LEDGES STATE PARK
CAMPGROUND RENOVATION AND ENTRANCE PORTAL
BOONE COUNTY, IOWA
PROJECT NO. 17-02-08-02

November 9, 2017

This Addendum is issued to modify, explain or correct the original Drawings and Specifications, and is hereby made a part of the Contract Documents. Please attach this Addendum to the Project Manual in your possession. Insert the number and issue date of this Addendum in the blank space provided on the Proposal Form.

SEWER & WATER DETAILS

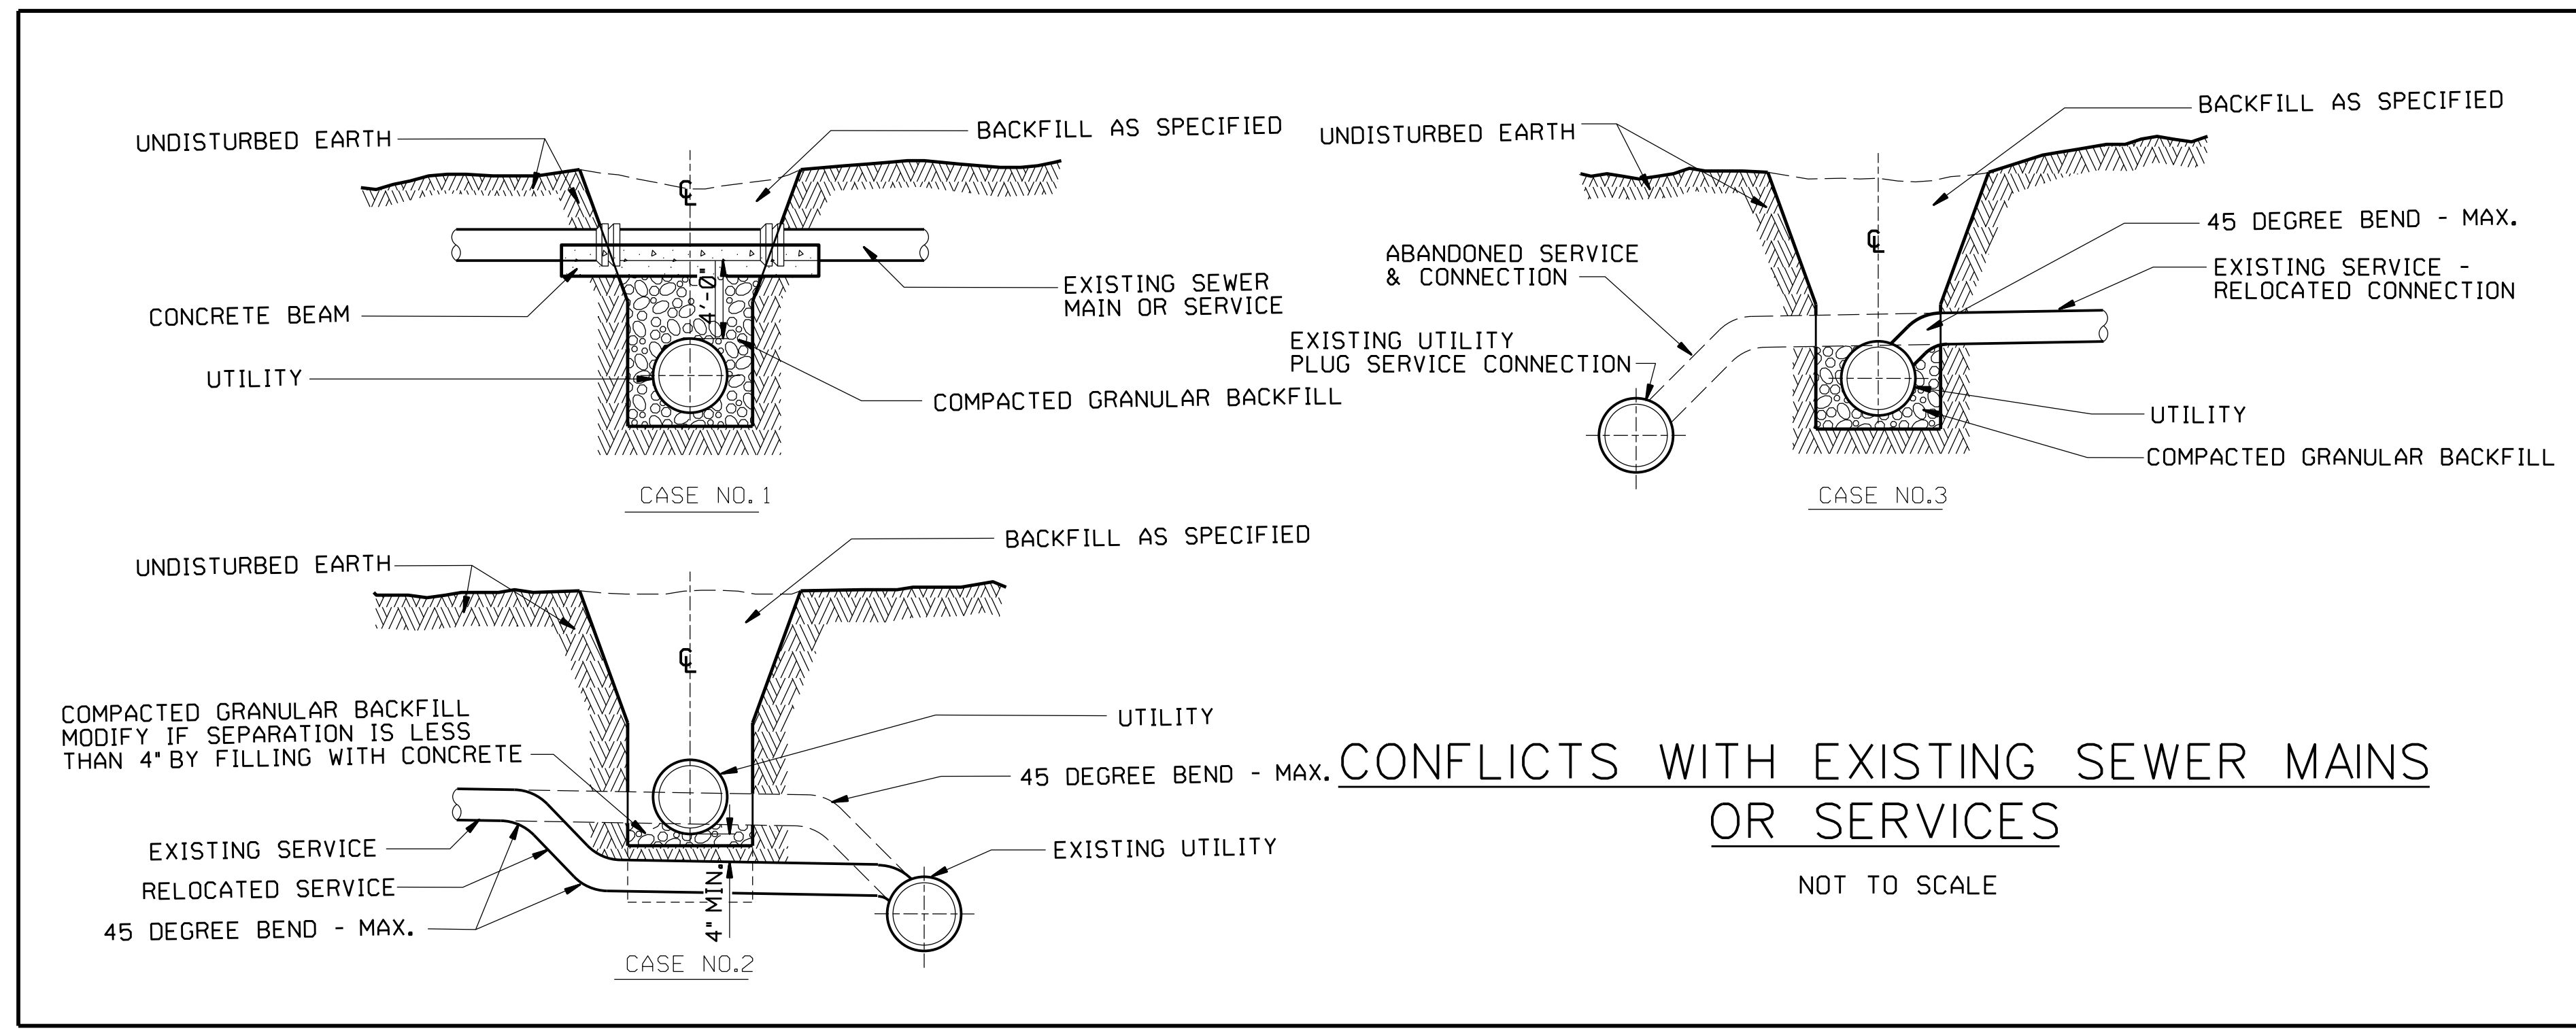
NO.	BY	REVISION
1	DDG	RV CONNECTION DETAIL

C.02

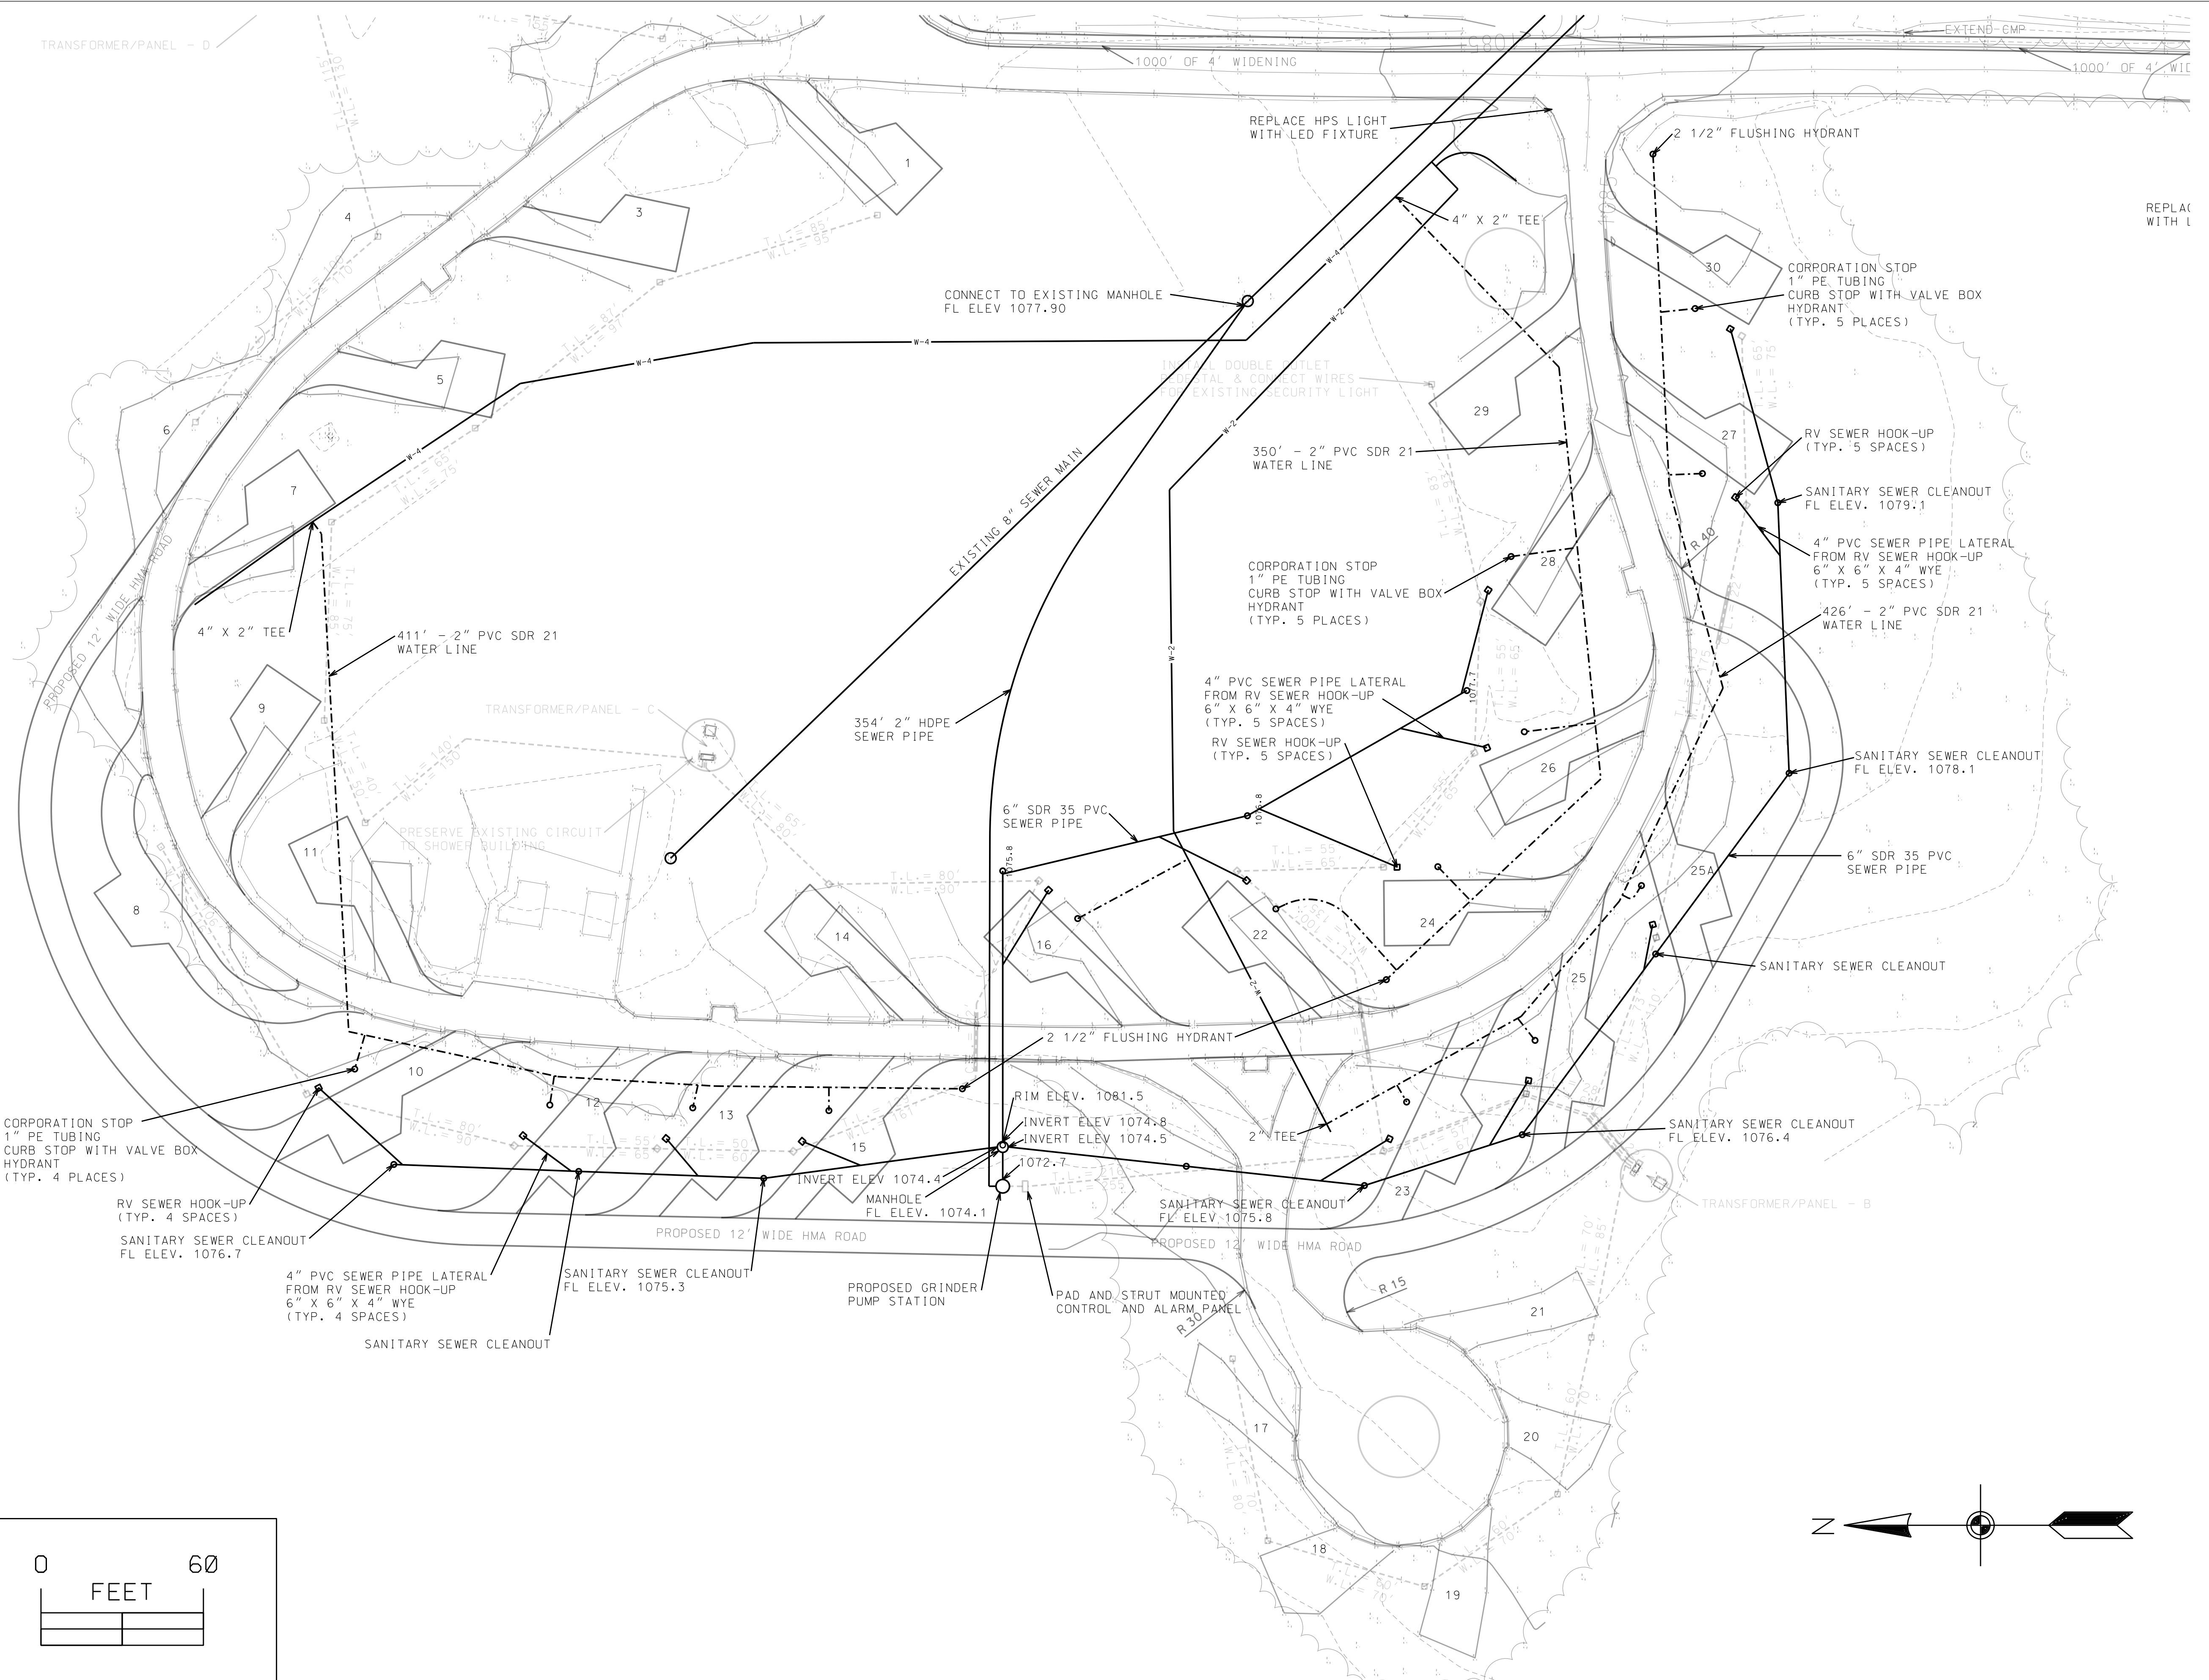
NO.	BY	REVISION
1	TDD	NOTES

SHEET No:
D.08

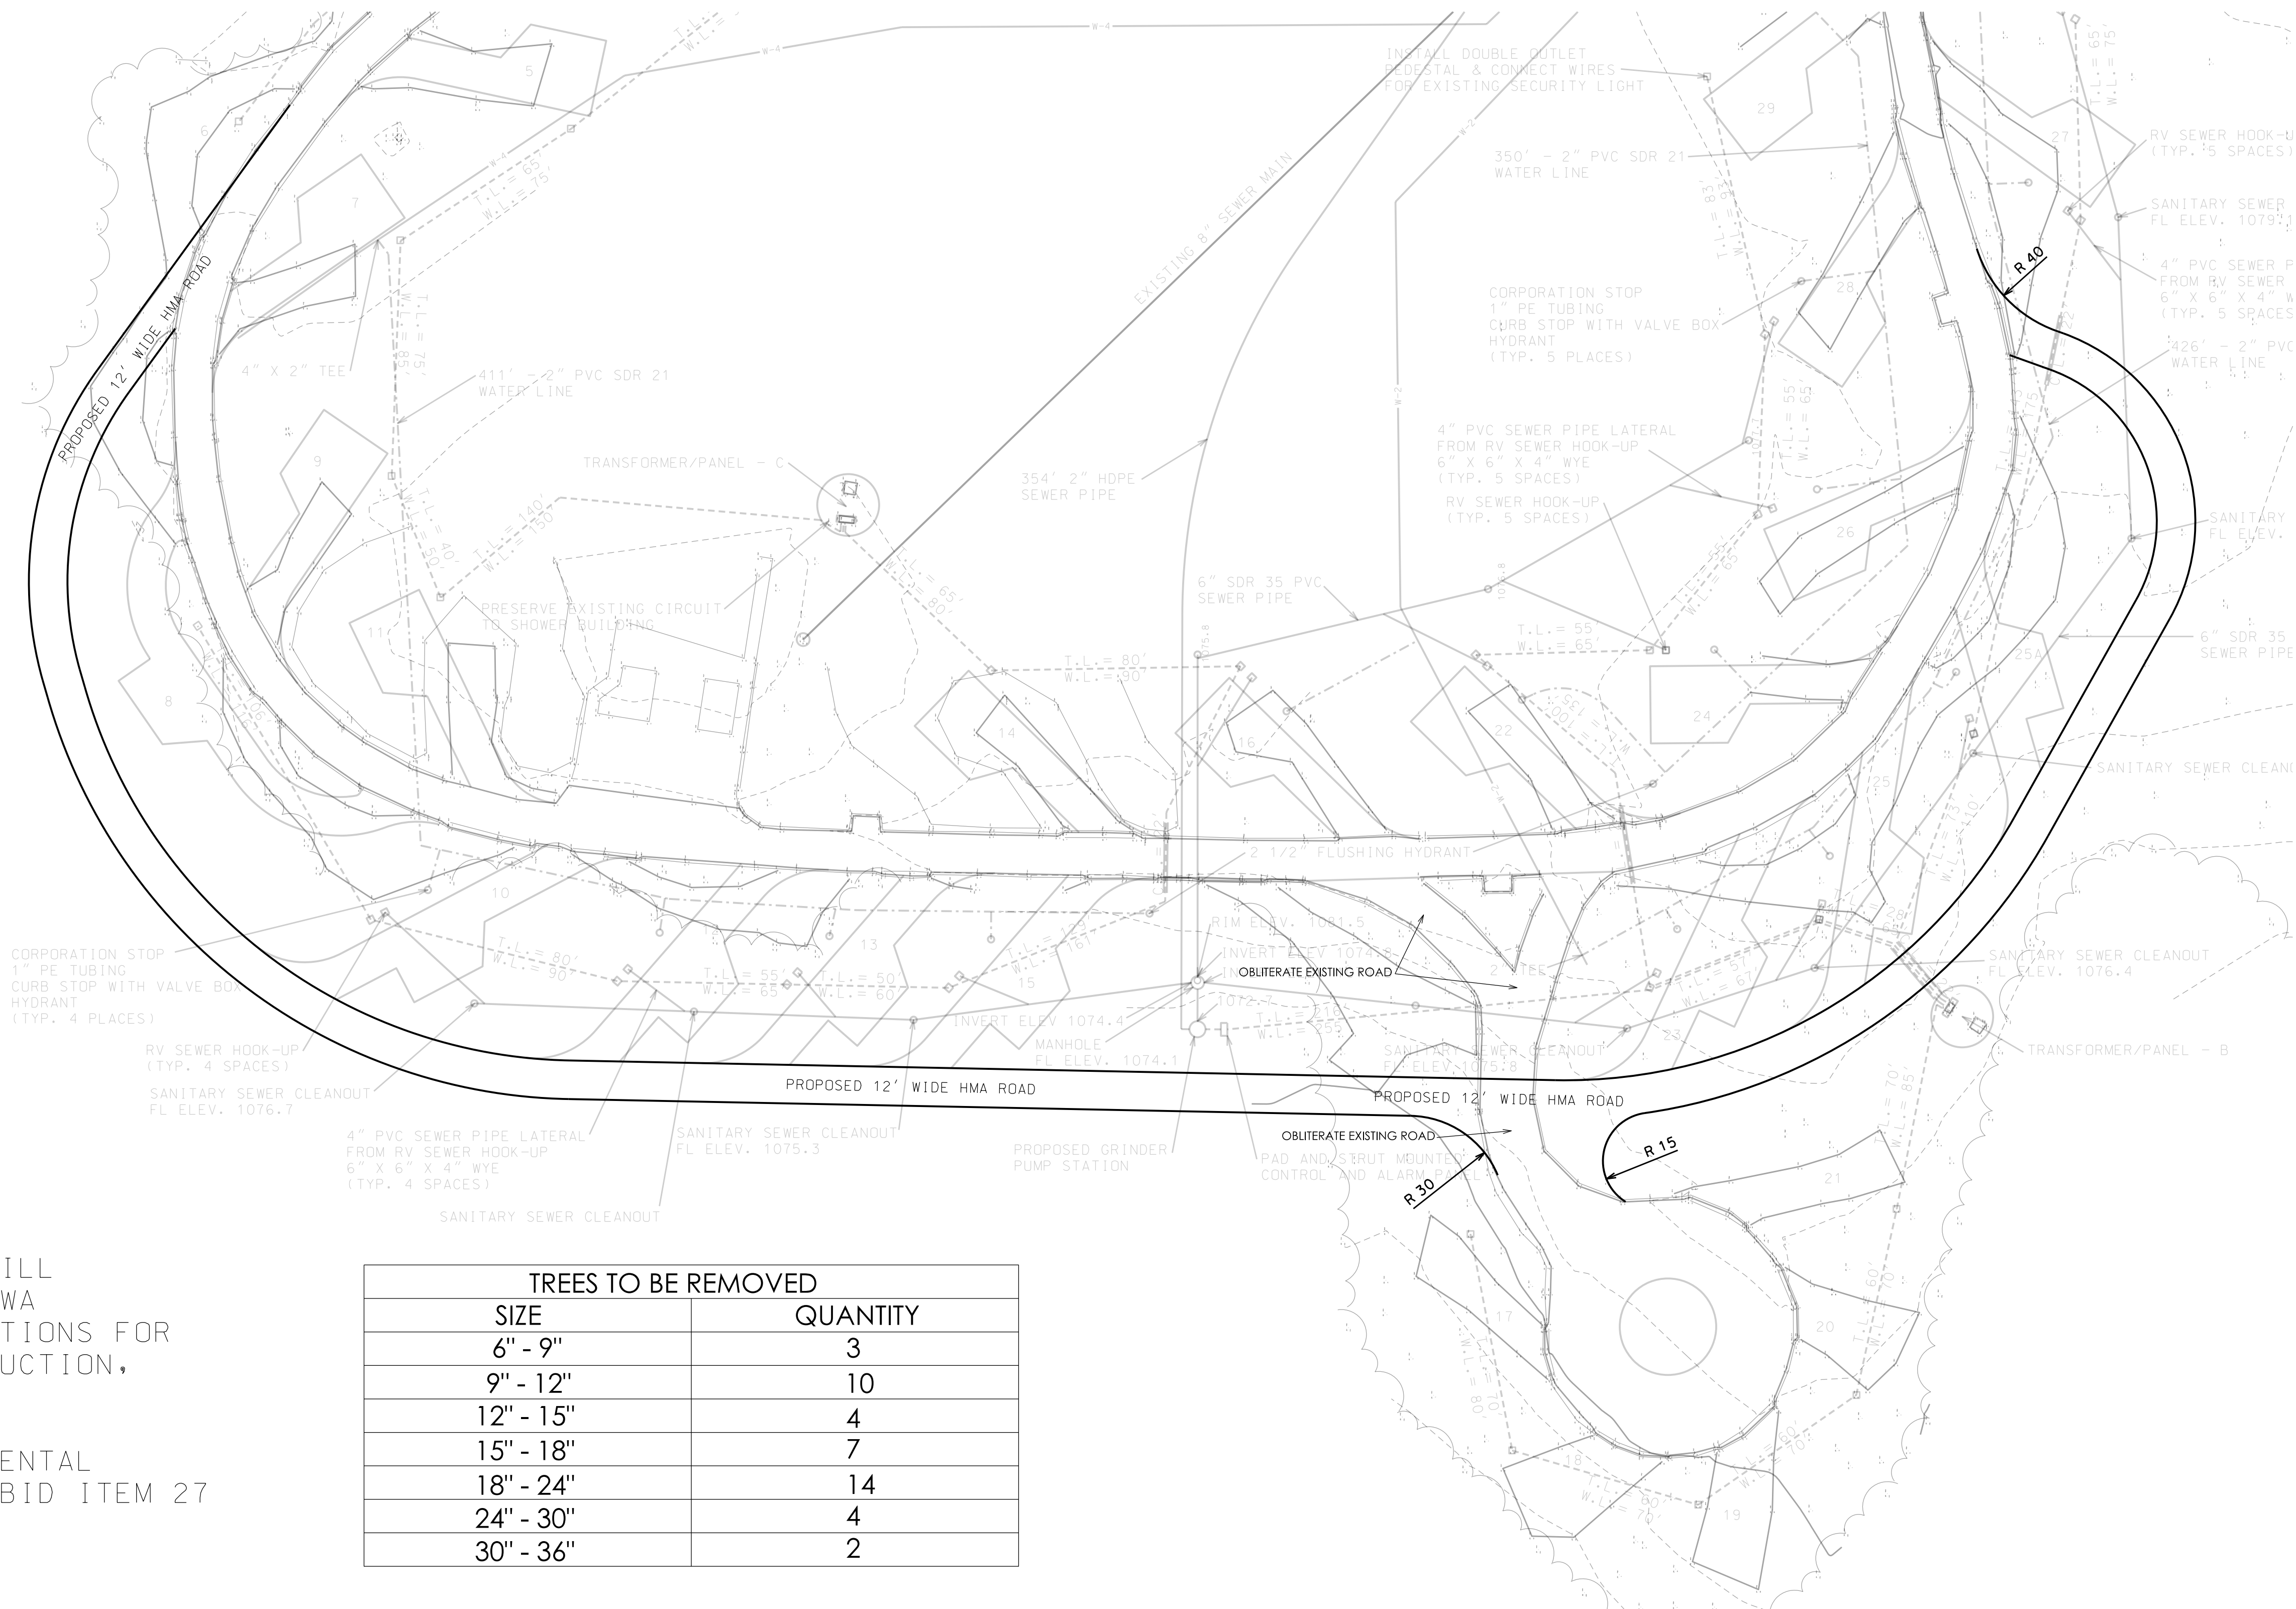
NO.	DATE	REVISION
1	T1/2017	SEWER LINE DIM
